<b>ITEM: 6.19</b>	<b>COMMITTEE OF ADJUSTMENT REPORT SUMMARY MINOR VARIANCE APPLICATION FILE NUMBER A283/22 25 SHALE CRESCENT, MAPLE</b>
-------------------	---

**COMMITTEE OF ADJUSTMENT REPORT  
MINOR VARIANCE APPLICATION  
A283/22  
25 SHALE CRESCENT, MAPLE**

<b>ITEM NUMBER: 6.19</b>	<b>CITY WARD #: 4</b>
<b>APPLICANT:</b>	Melita and Eyal Sager
<b>AGENT:</b>	Millennium Landscape Design & Construction
<b>PROPERTY:</b>	25 Shale Crescent, Maple
<b>ZONING DESIGNATION:</b>	See Below
<b>VAUGHAN OFFICIAL PLAN (2010) DESIGNATION:</b>	Vaughan Official Plan 2010 ('VOP 2010'): "Low-Rise Residential"
<b>RELATED DEVELOPMENT APPLICATIONS:</b>	None
<b>PURPOSE OF APPLICATION:</b>	Relief from the Zoning By-law is being requested to permit an existing cabana and deck.

1 | SITE PLAN  
A1 | 3/32"=1'-0"

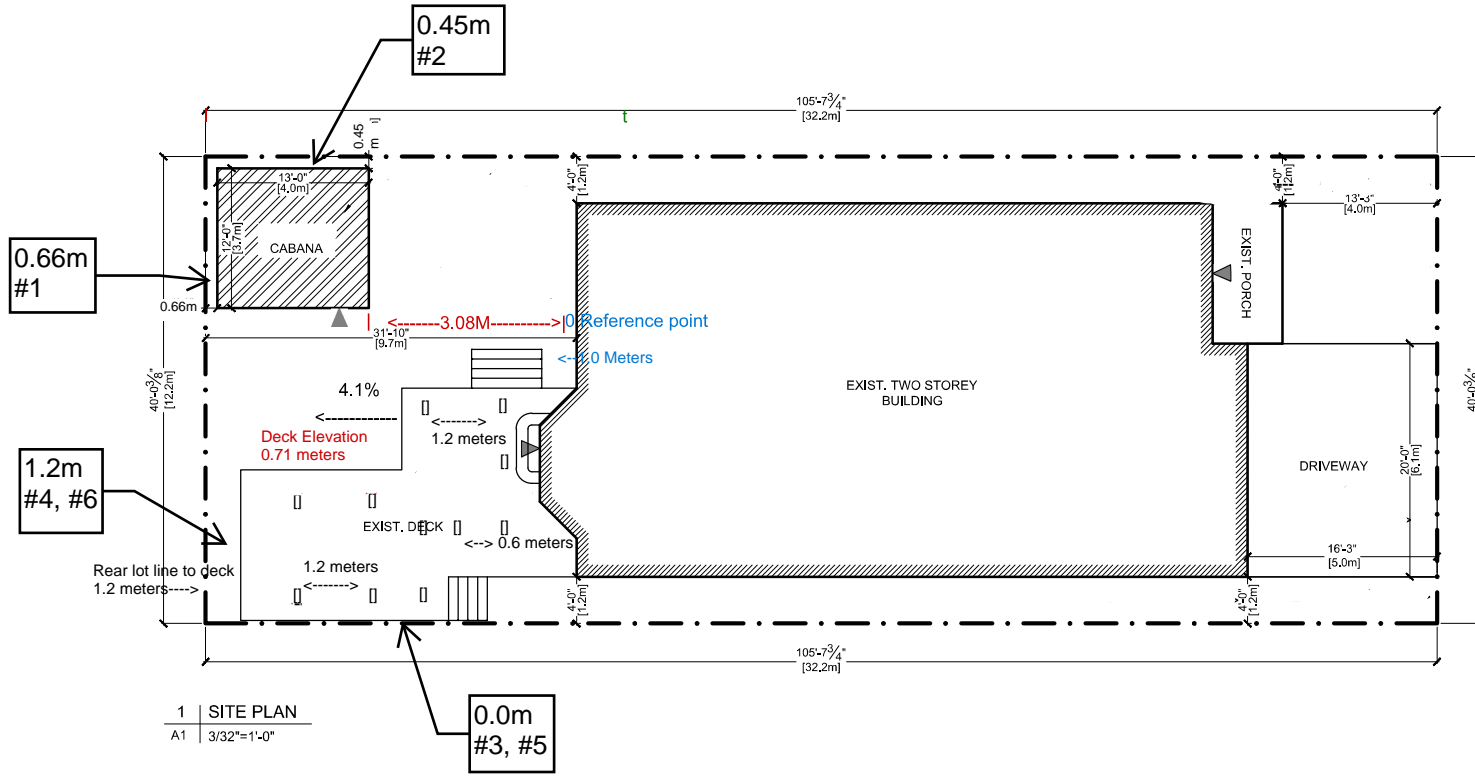
The Development Planning Department has no objection to Variances 1 and 2 for the existing cabana as the reduction to the rear yard setback will not pose a significant adverse massing impact to the abutting properties. The cabana complies with the height provisions. The rear yard is graveled and provides sufficient space for maintenance access. Given that the interior side yard is graveled, and that the cabana's eave and gutter is not located in the interior side yard, the reduced setback of 0.45 m maintains sufficient area for some maintenance access and will not significantly adversely impact the abutting properties. The Development Engineering Department has also reviewed correspondence provided by the Owners of 21 Shale Crescent, noting that the reduced side yard setback has not resulted in ponding, pooling, or damming on their property, and has no objection to Variances 1 and 2.

The Development Planning Department is not in a position to support Variances 3, 4, 5 and 6 for the encroachment of the existing deck and stairs into the interior side yard and the deck into the required rear yard. While Development Engineering has reviewed the above noted variances and have no concerns with the encroachment of the deck and stairs into the required interior side yard and rear yard from a lot grading and drainage

perspective, Development Planning is of the opinion that a 0.0 interior side yard setback and a 6.3 metre encroachment into the rear yard will impact the functionality and maintenance of the rear yard by providing little to no access around the deck structure, and will result in significant massing and privacy impacts to abutting properties. The Development Planning Department has conducted a review of the wider neighbourhood to determine if any similar variances have been approved through Minor Variance and it has been confirmed that the proposal is not consistent with previous approvals in the neighbourhood.

With respect to function 1, the existing deck does not provide adequate separation of mass between properties as the 0.71 m high deck spans nearly the entire depth of the rear yard. The height of the deck elevates the activity and items placed upon it, which has resulted in the installation of a privacy screen on top of it in relation to the side lot line in order to better screen the activity and items visible above the fence.

The Development Planning Department recommends **approval** of Variances 1 and 2, and **refusal** of Variances 3, 4, 5 and 6, as noted above.
